# HIGHLAND SPRINGS COMMERCIAL ADDITION WICHITA, SEDGWICK COUNTY, KANSAS

RE: S/D 00-15 -- Final Plat of HIGHLAND SPRINGS COMMERCIAL ADDITION

At the regular meeting of the Subdivision Committee of the Metropolitan Area Planning Commission on Thursday, March 23, 2000, the above captioned plat was considered. The action of the Committee was to approve the final plat, subject to:

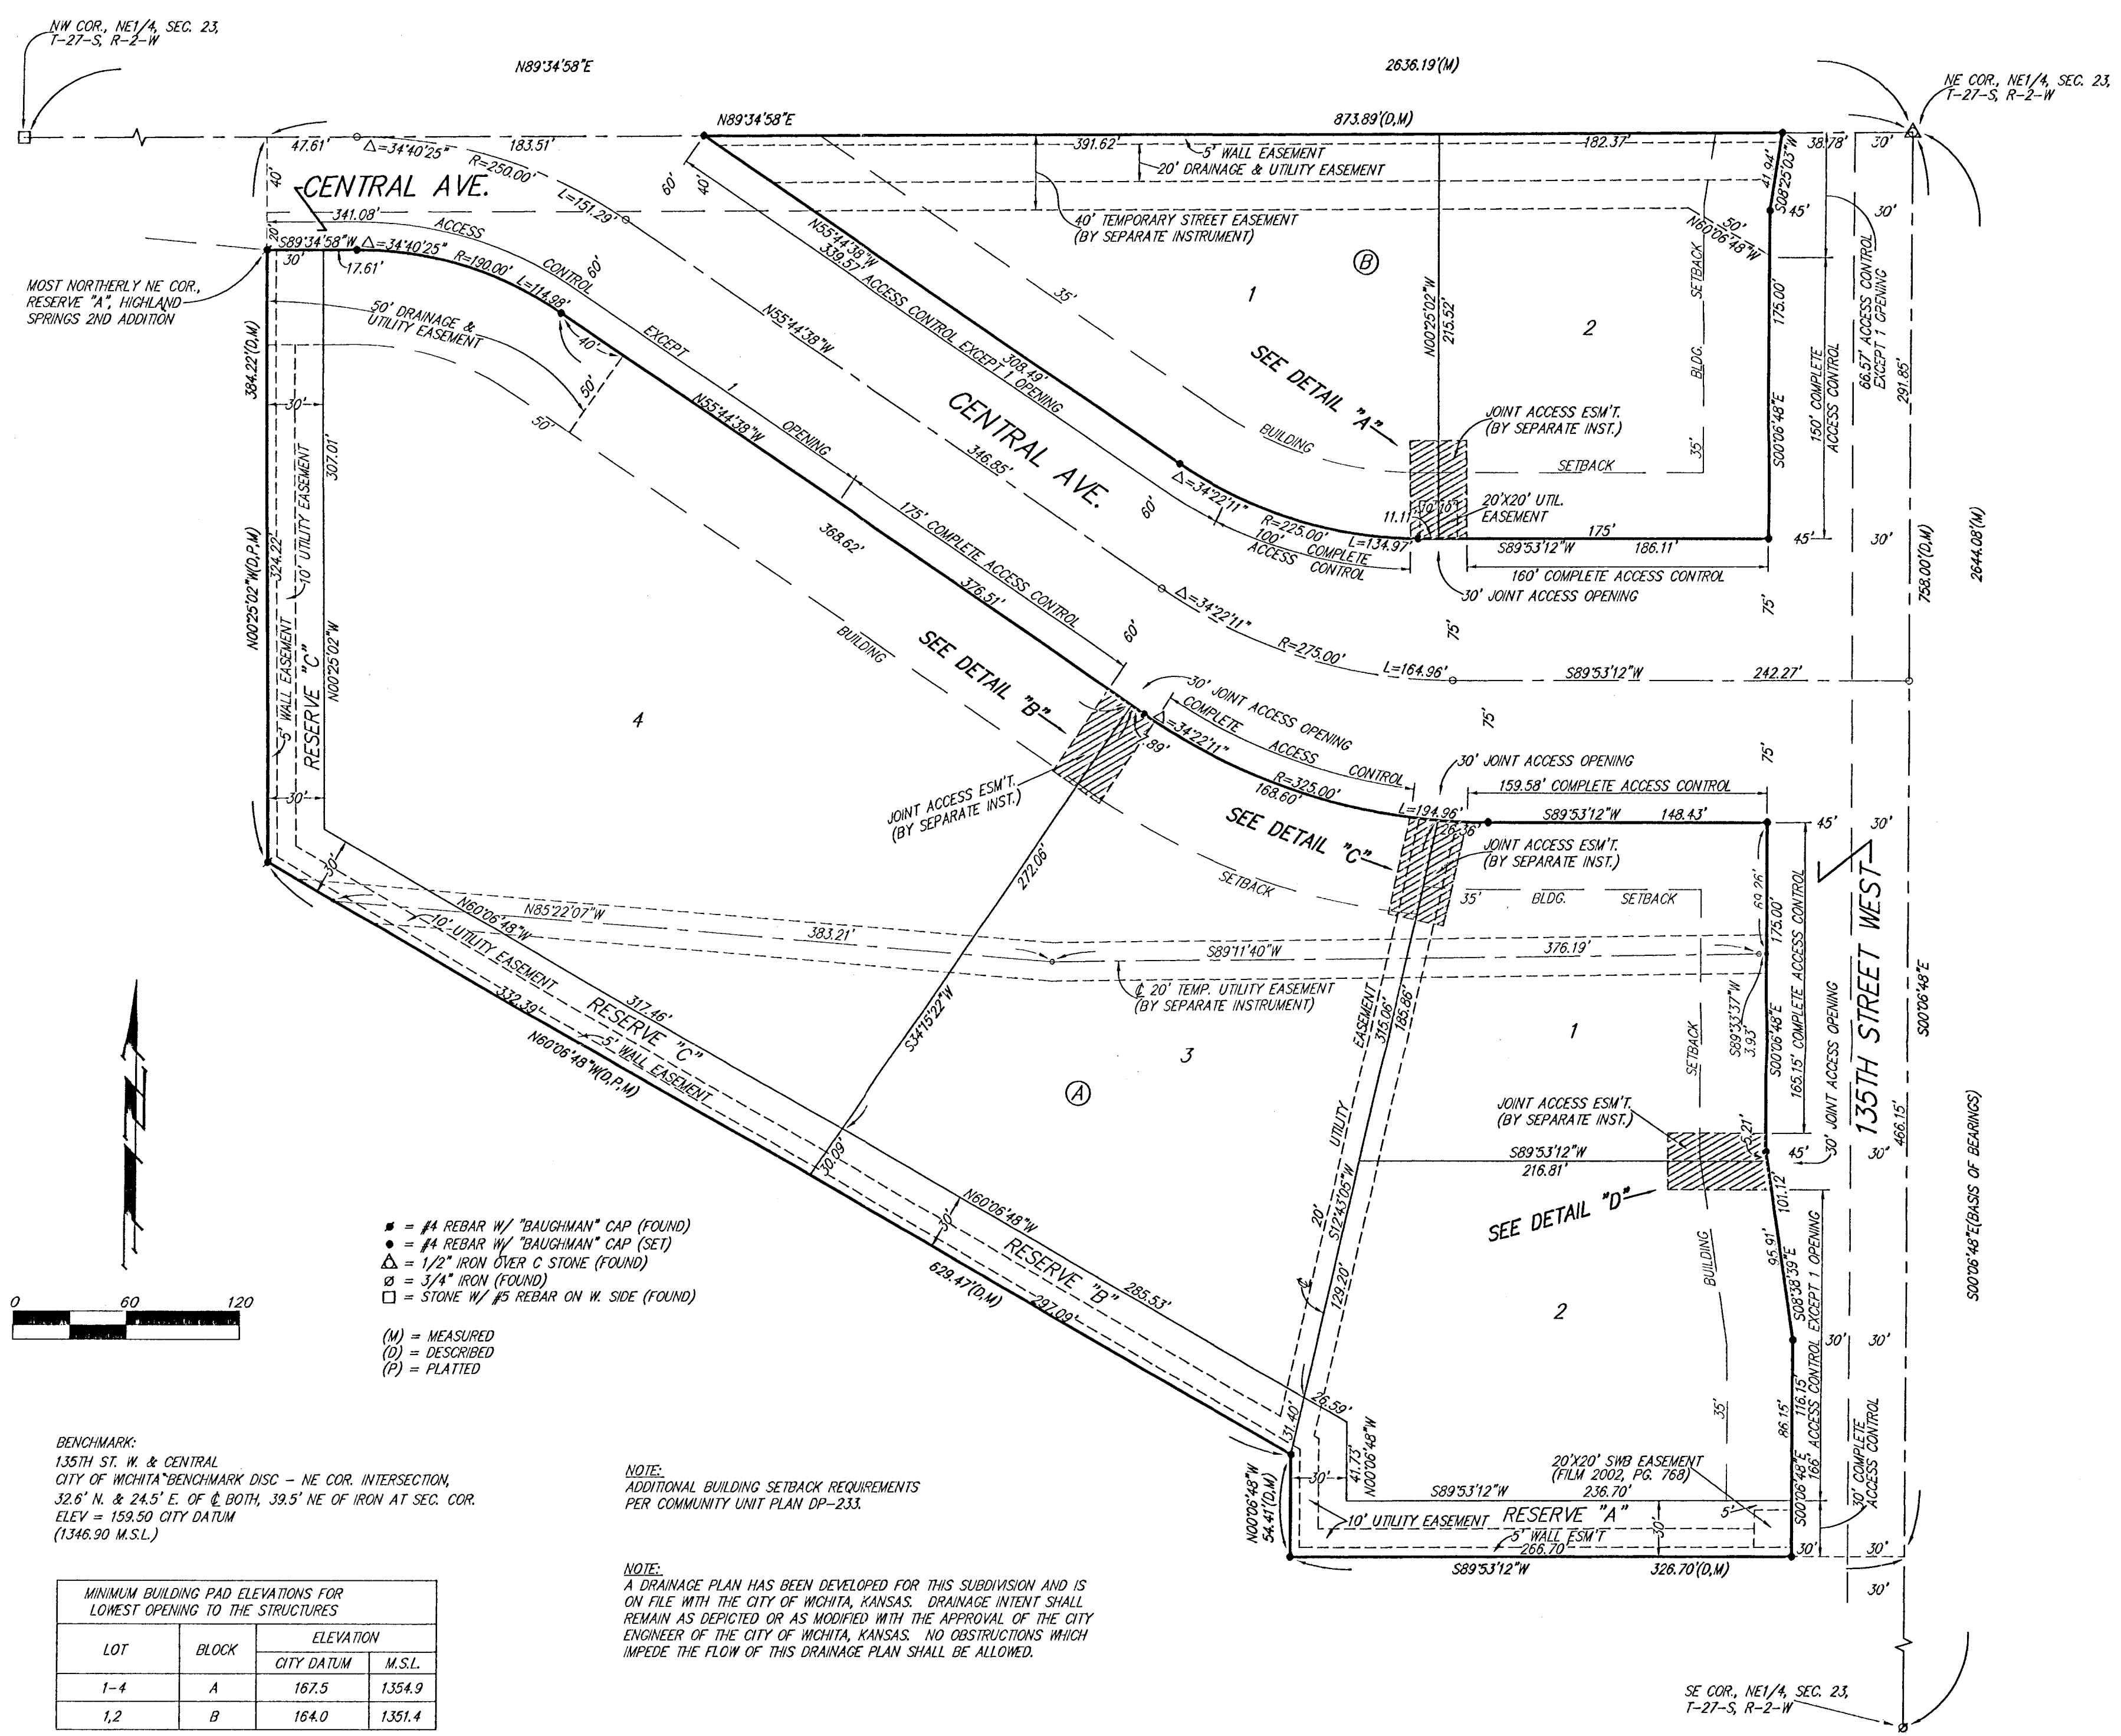
- C. City Engineering needs to comment on the status of the applicant's drainage plan. The drainage plan is approved. A drainage guarantee is required. A drainage easement is required.

- D. The definite location of the KGE temporary easement needs to be provided on the plat.
- E. Traffic Engineering needs to comment on the access controls. The plat proposes three access openings along the south side of Central, including two joint openings. On the north side of Central two access openings are proposed, including one joint opening. Along 135<sup>th</sup> St. West, the plat proposes one access opening north of Central and two openings south of Central. For Lot 2, Block B, 150 feet of complete access control is required along 135<sup>th</sup> St. Distances should be shown for all segments of access control. In accordance with the Subdivision regulations, any access openings located within 250 feet of the intersection of Central and 135<sup>th</sup> St. West are limited to right-turns only, and shall be referenced on the face of the plat; or a guarantee provided for the future construction of a raised medial. The final plat shall reference the access controls in the plat's text.

- F. In accordance with the CUP, the following improvements are required: a) a guarantee for the construction of Central to three lanes between 135<sup>th</sup> St. West and where the realigned street meets the present location of Central and b) construction of a three lane roadway between the south line of Lot 2, Block A, and the north line of Lot 2, Block B along 135<sup>th</sup> St. West.

- D. The definite location of the KGE temporary easement needs to be provided on the plat.
- E. Traffic Engineering needs to comment on the access controls. The plat proposes three access openings along the south side of Central, including two joint openings. On the north side of Central two access openings are proposed, including one joint opening. Along 135<sup>th</sup> St. West, the plat proposes one access opening north of Central and two openings south of Central. For Lot 2, Block B, 150 feet of complete access control is required along 135<sup>th</sup> St. Distances should be shown for all segments of access control. In accordance with the Subdivision regulations, any access openings located within 250 feet of the intersection of Central and 135<sup>th</sup> St. West are limited to right-turns only, and shall be referenced on the face of the plat; or a guarantee provided for the future construction of a raised medial. The final plat shall reference the access controls in the platting's text.

- T. The representatives from the utility companies should be prepared to comment on the need for any additional utility easements to be platted on this property. **KGE requests a temporary easement to cover their line until Central is realigned. Any relocation or reconstruction of utilities made necessary by this plat shall be the responsibility of the Applicant.**
